RE: Boyce Street Mixed-Use Development
101 West Boyce Street, Manor, TX, 78653
Permit No.: 2024-P-1645-SP
SWE Project No. 1168-001-24

RE: Boyce Street Mixed-Use Development (2024-P-1645-SP)
101, 104, 107 & 108 West Boyce Street, Manor, TX 78653
Detention Waiver Request Letter
SWE Project No. 1168-001-24

DETENTION WAIVER SUBMITTAL PACKAGE FOR BOYCE STREET MIXED-USE DEVELOPMENT

PROPOSED DRAINAGE AREA MAP

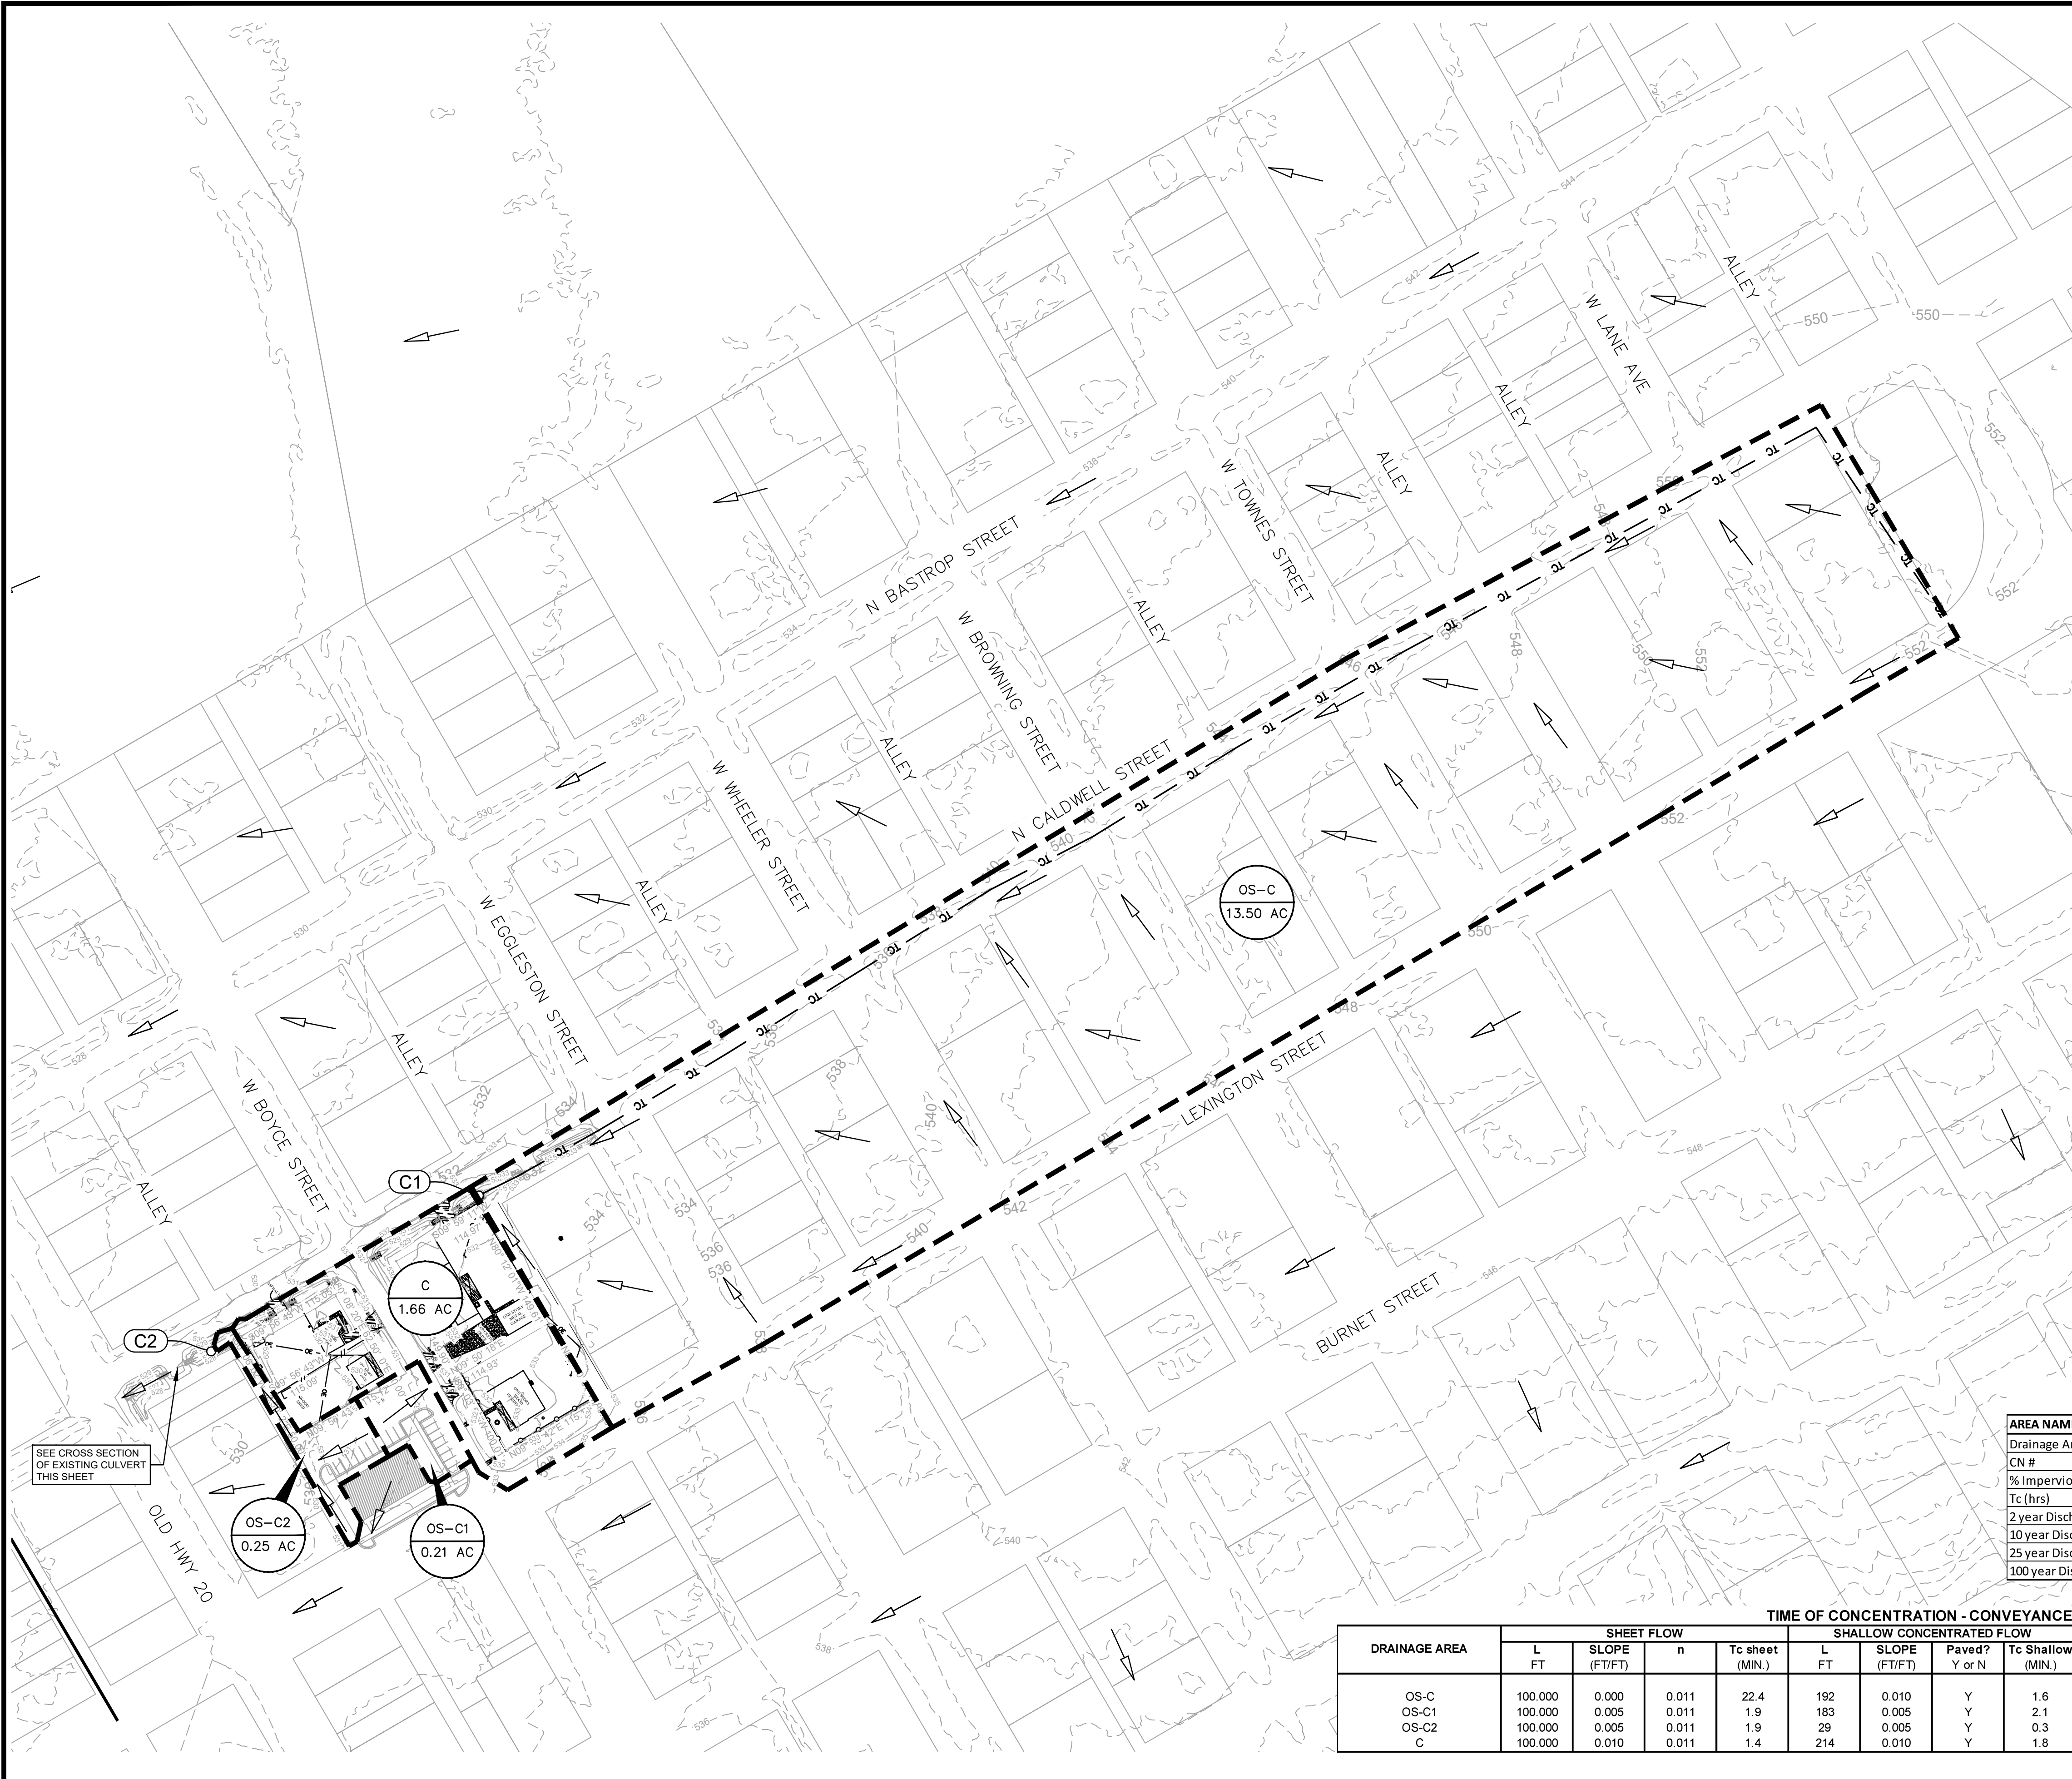
5. On the proposed Drainage Area Map (Sheet 8 of 30), clearly show the proposed storm sewer line. Currently, everything looks in gray scale and it is difficult to distinguish between existing and proposed infrastructure.

7. Add an additional table in the proposed drainage sheet, something like this:

8. Add an additional table in the proposed drainage sheet related to total exceedances for site plan, something like this:

Comment Response: The proposed storm sewer line is now more prominent and shown darker on the Proposed Drainage Area Map (Sheet 8).

Comment Response: The tables requested are now included on the Proposed Drainage Area Map (Sheet 8).

Comment Response: The table requested is now included on the Proposed Drainage Area Map (Sheet 8).

POA A EX	POA A PR	Exceedances
2-yr	6.1	8.5	2.4
10-yr	10.7	14	3.3
25-yr	13.8	17.7	3.9
100-yr	19	23.9	4.9

POA B EX	POA B PR	Exceedances
2-yr	0.9	1.5	0.6
10-yr	1.6	2.3	0.7
25-yr	2.2	2.9	0.7
100-yr	3	3.8	0.8

Total Exceedances for Site Plan	
2-yr	3
10-yr	4
25-yr	4.6
100-yr	5.7

EXISTING CONVEYANCE DRAINAGE AREA MAP

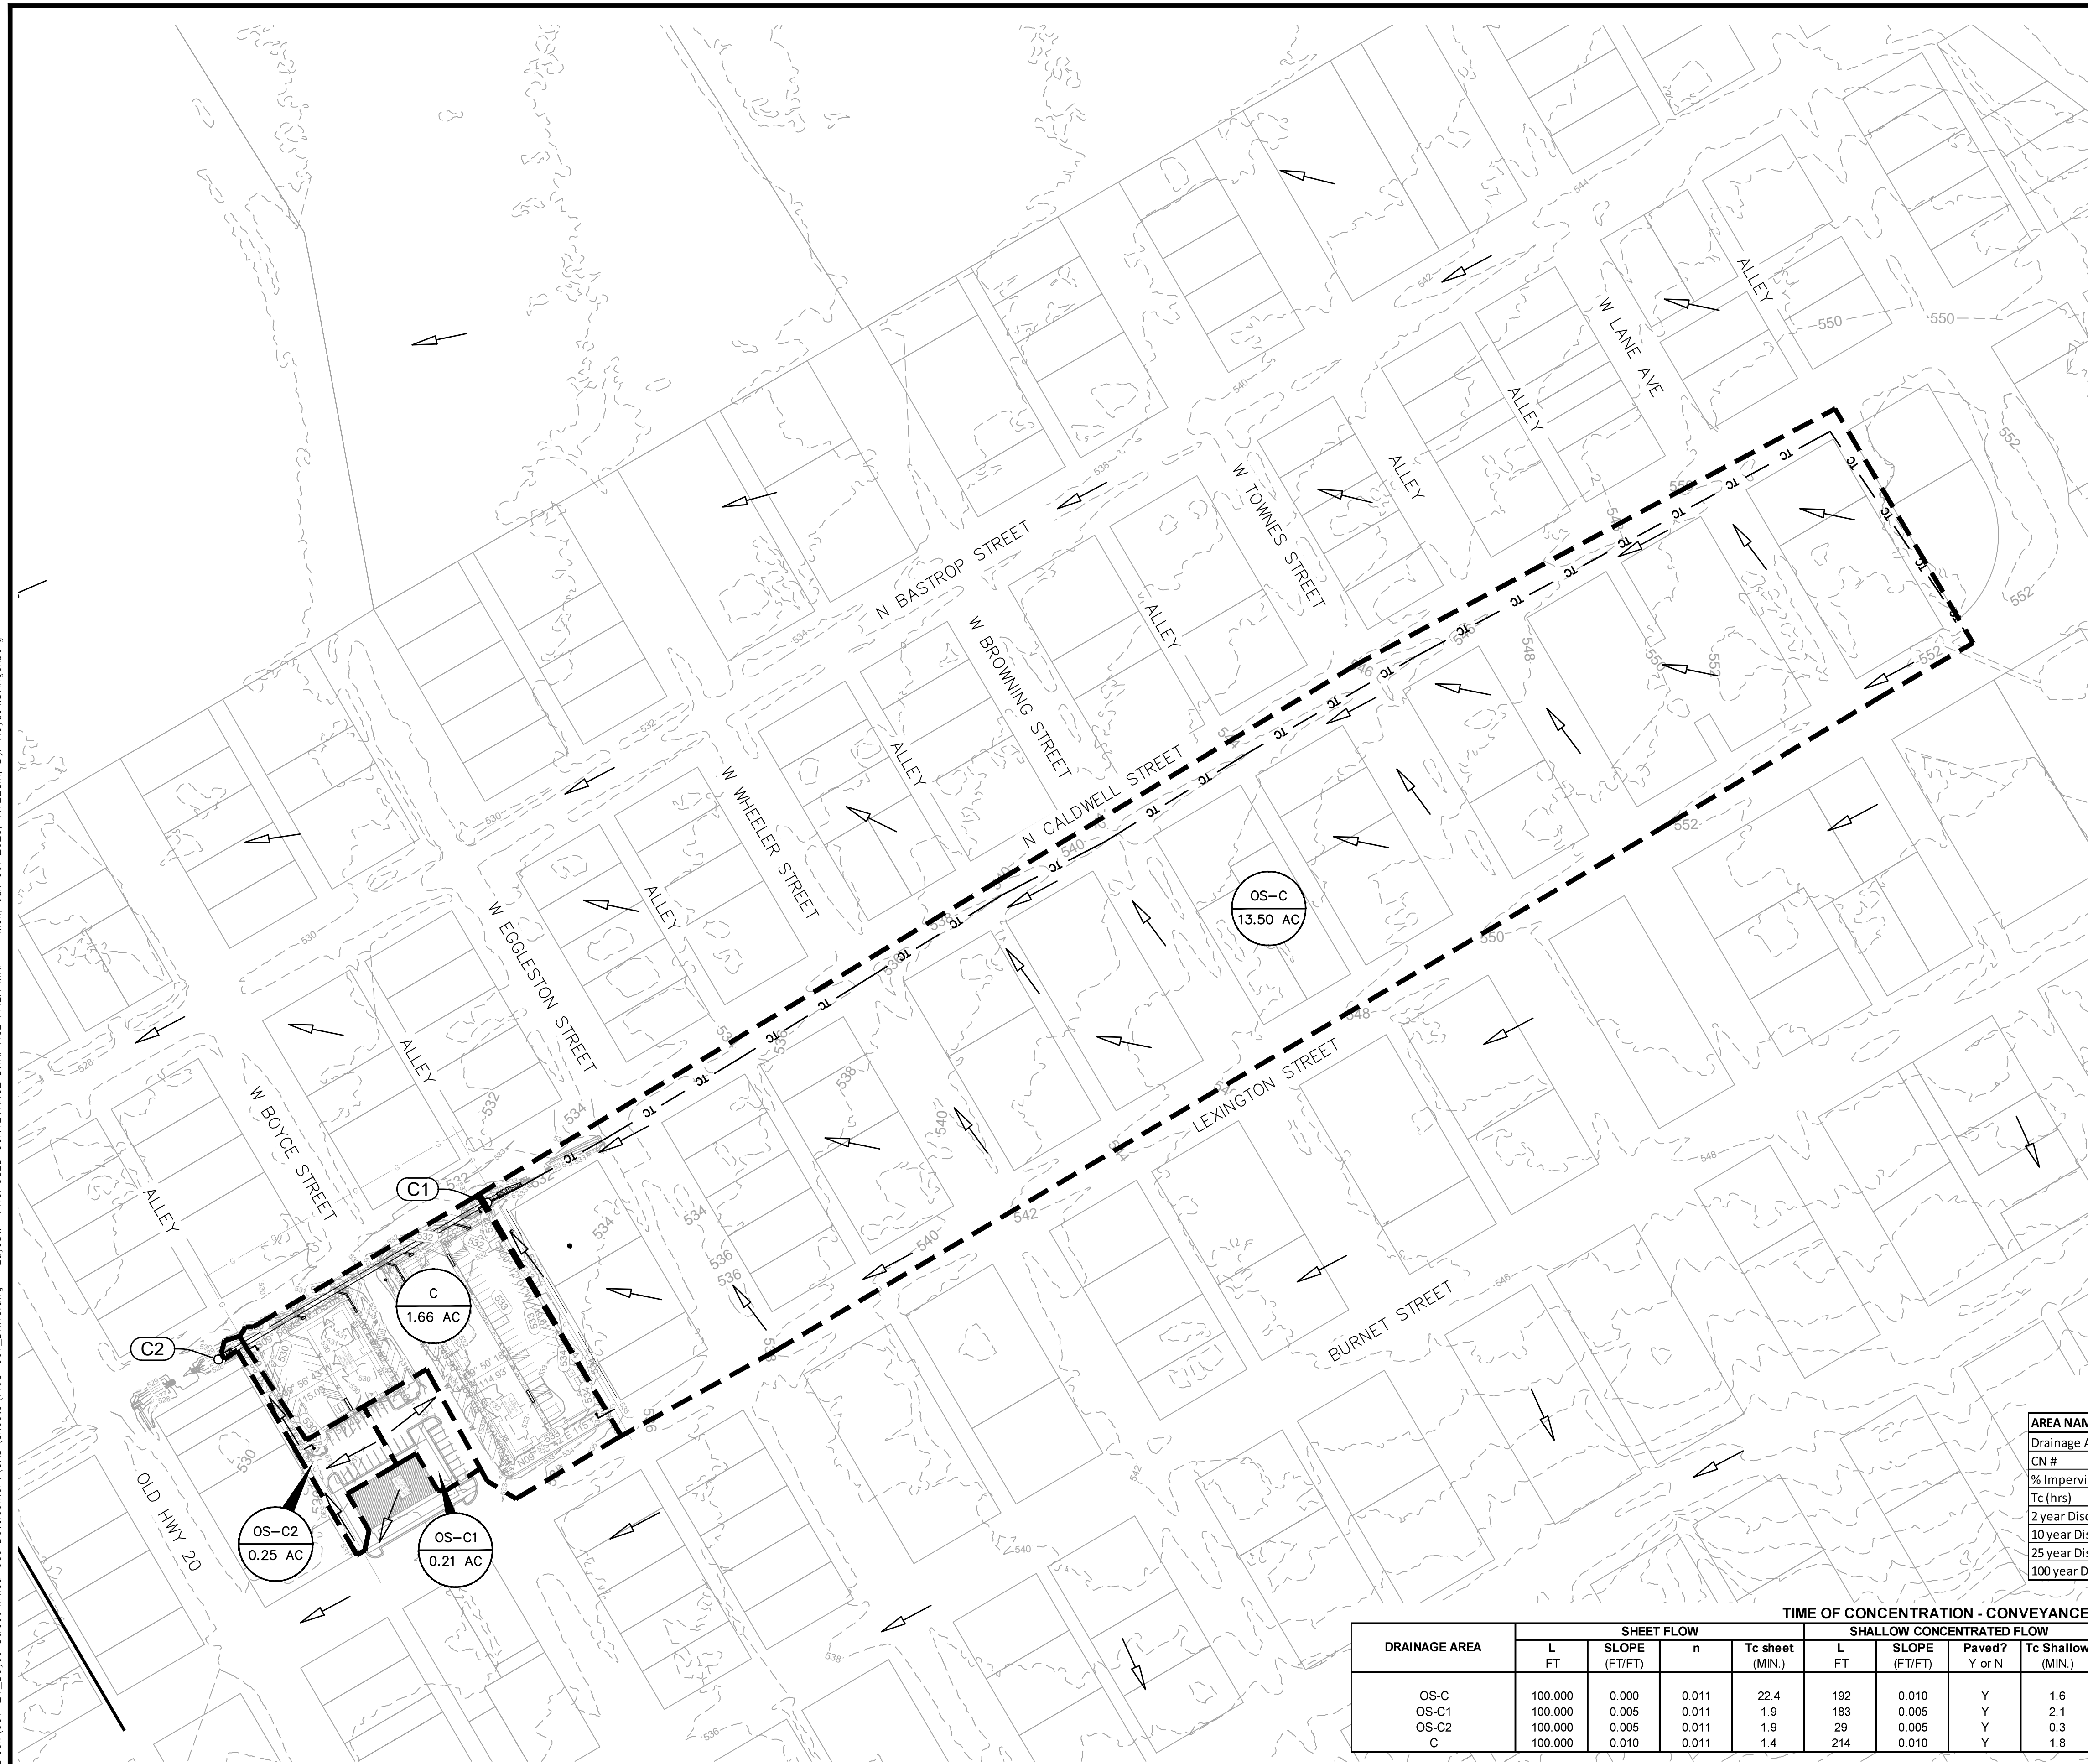
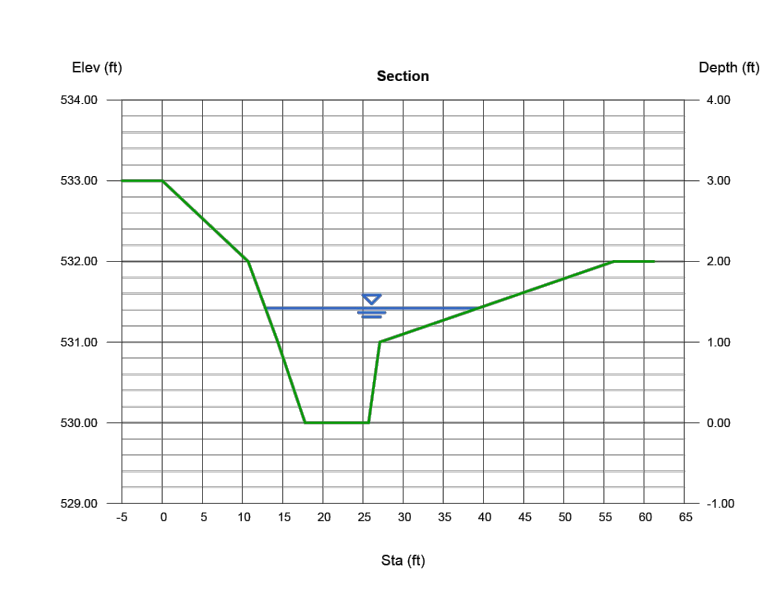
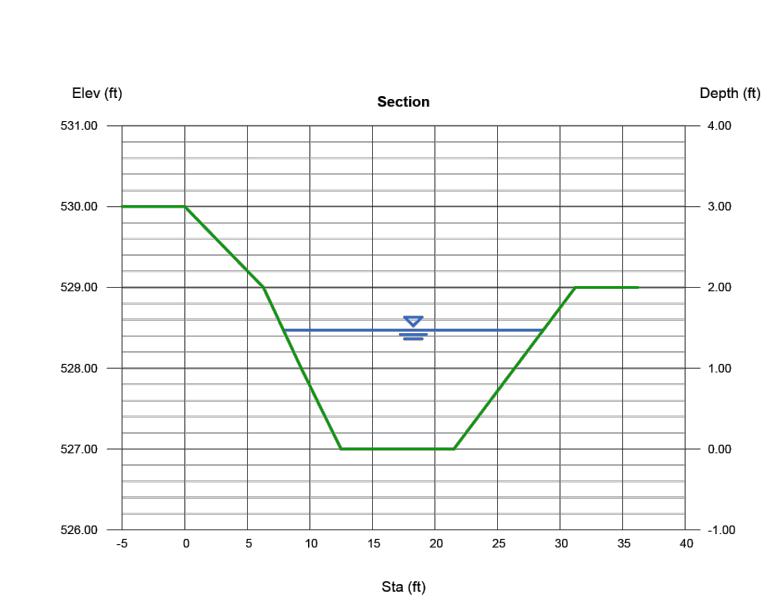
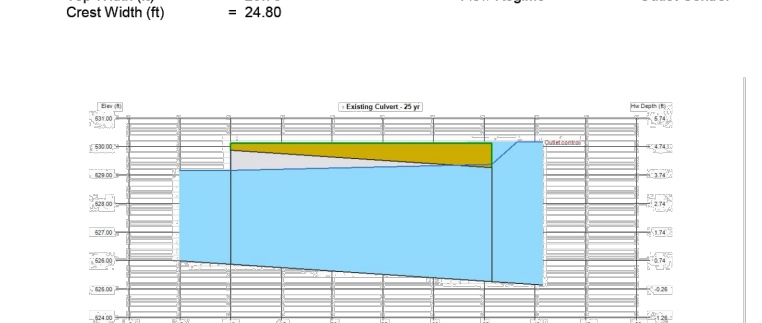
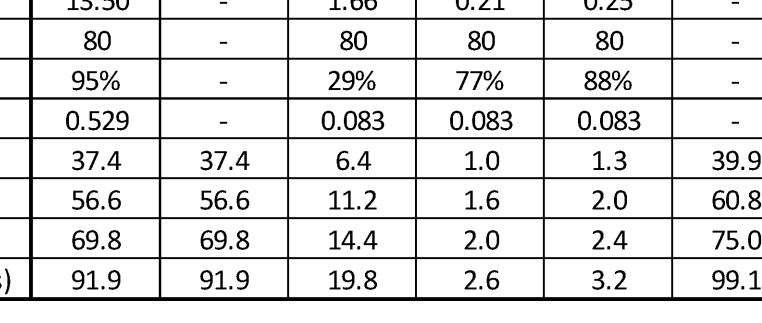
10. Provide H&H calculations (one cross section) for existing east side ditch of N Caldwell Steet between the proposed discharge point of storm sewer and Old Hwy 20

11. Provide H&H calculations for existing culvert along existing east side ditch on N Caldwell Steet which crosses Old Hwy 20.

- a. Comment remains. Provide H & H calculation for existing culvert at drive way (downstream of culvert discharge), ditch between this ex culvert at DW and Ex Culvert at W Parson St (Old Hwy 20) and culvert under W Parson St (Old Hwy 20).

Comment Response: A cross section is provided for this location on the Existing Conveyance Drainage Area Map (Sheet 9), see cross section “Existing Roadside Ditch at POA-C2”.

Comment Response: A cross section is provided the existing culvert for this location on the Existing Conveyance Drainage Area Map (Sheet 9), see cross sections “Existing Culvert 25-yr”, “Existing Culvert 100-yr”.
